10/655,894

Takahiro Kawaguchi

Office Action Summary

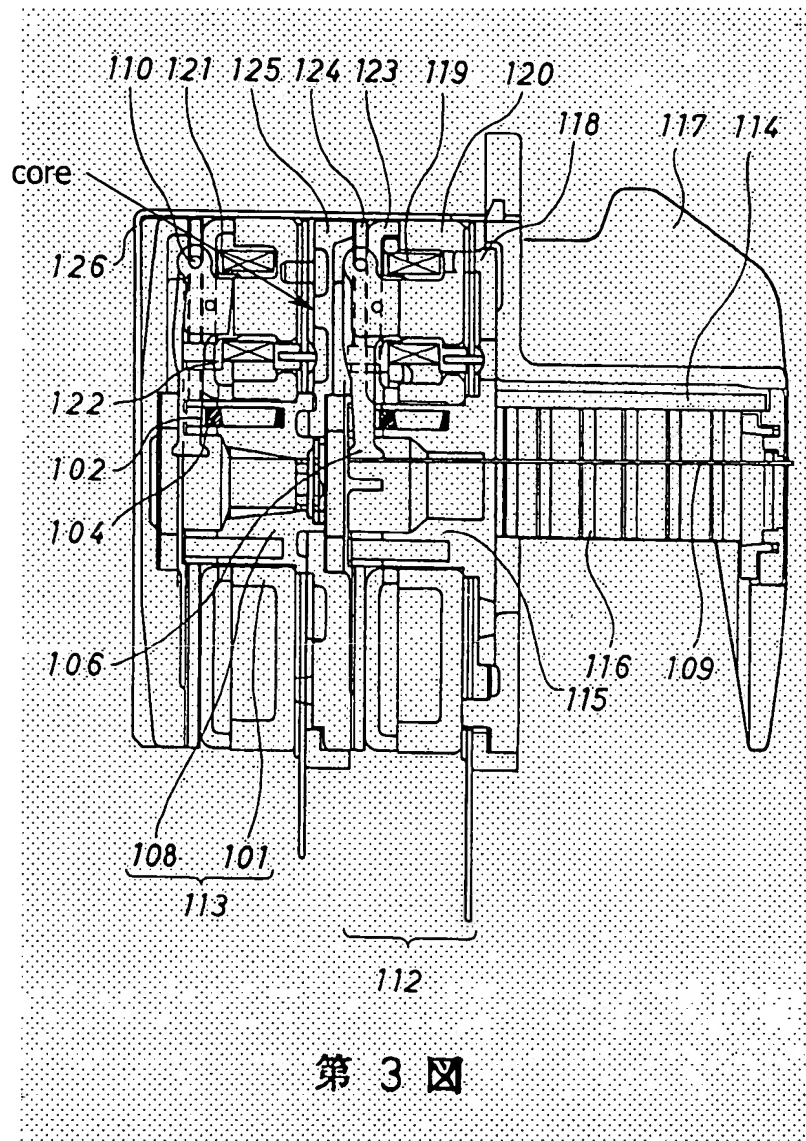
With respect to claim 1, Iinuma discloses a wire dot print head including a plurality of cores 8b each with a wound coil 6, a plurality of armatures 2 each having an arm (the leftmost portion of the armature 2) supporting a printing wire 1 and each rockably mounted opposite the plural cores as shown in Figure 1 and disclosed in the last sentence of the English abstract of Iinuma. Further disclosed are a plurality of receiving members 12a in the shape of a plate and mounted on the core side of the arm as shown in Figure 1 and a plurality of pressing members 11 each in contact with the plurality of receiving members and pressing the armatures away from the cores. Iinuma also discloses a thickness of the arm being thinner than a thickness of the armature as shown below in the Figure taken from Figure 3 of Iinuma:

With respect to claim 2, the term “unitarily” can mean “forming a unit.” The receiving member 12a and the arm can be considered a printing wire unit, therefore they are unitarily formed.

With respect to claim 4, the receiving member 12a is disposed orthogonally to the direction of pressure application by the pressing member as shown in Figure 1 of Iinuma.

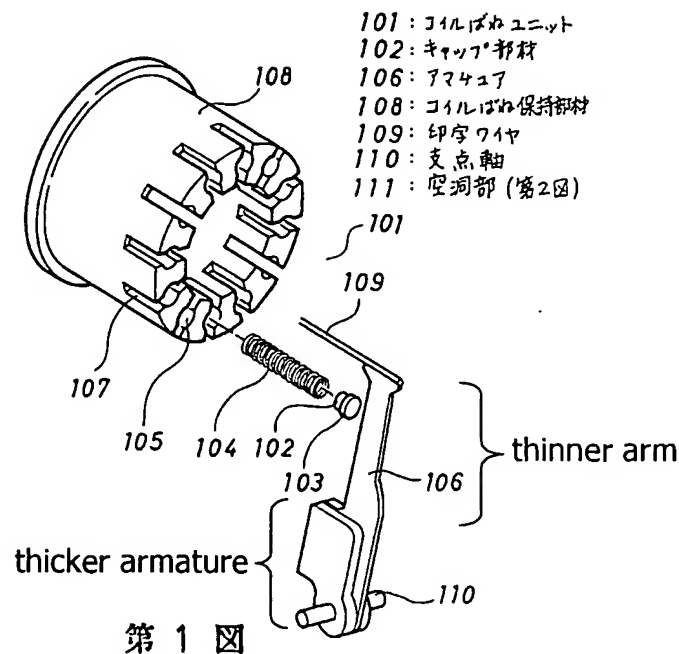
et al.) in which at least the top portion is in the shape of a plate and mounted on the core side of the arm as indicated by Figure 1 and a plurality of pressing members 104 each in contact with the plurality of receiving members and pressing the armatures away from the cores. Figure 1 of Sato also shows that the arm is thinner than the armature as marked below:

With respect to claim 5, Figure 1 of Sato et al. shows that the end face on the core side of the arm is smaller in width than the pressing member.
